# Yamada Bulletin

No. 2016-05

## CHANGE OF PILOT VALVE FOR NDP-40 AND 50 SERIES

832162 PILOT SHAFT ASSY

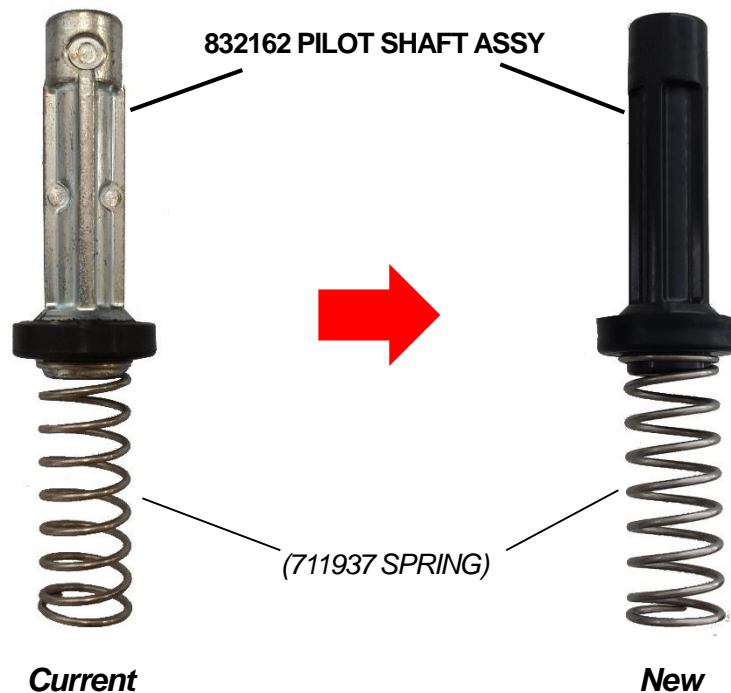
Pilot valve for NDP-40 and NDP-50 series have design change

Material is changed from zinc alloy to polycarbonate

As soon as the present stock has run out
